STAFF REPORT
(One-Step Final Plat, Final Plat Deferred 7/20/06)

CASE NUMBER: SUB 2005-140 -- TERRADYNE WEST ADDITION

OWNER/APPLICANT: Terradyne West, Attn: Craig Smith, 9340 E. Central, Wichita, KS 67206

SURVEYOR/ENGINEER: Poe and Associates, Inc., 5940 E. Central, Wichita, KS 67208

VICINITY MAP

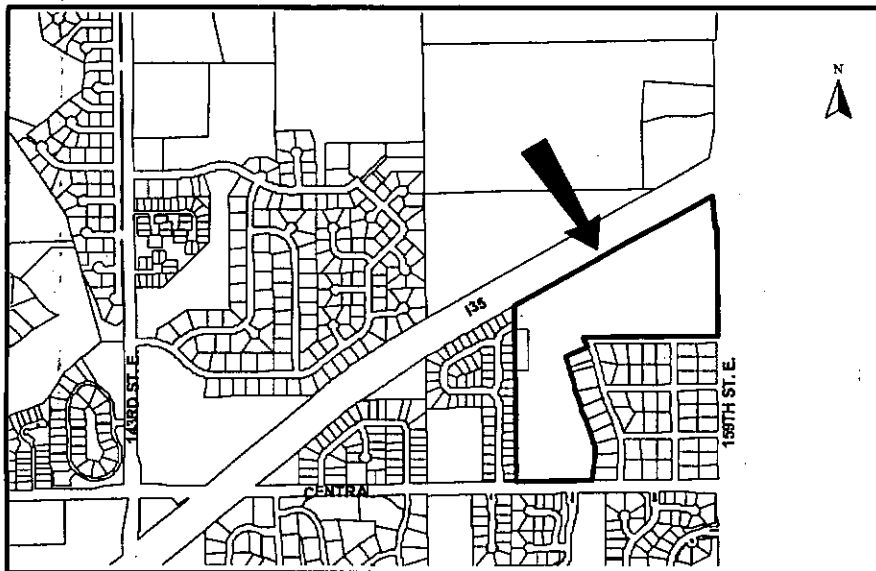
NOTE: This site is located in the County adjoining Wichita's city limits and annexation is required. The site is currently zoned SF-20, Single-Family Residential and will be converted to SF-5, Single-Family Residential upon annexation. The site is located within the 100-year floodplain.
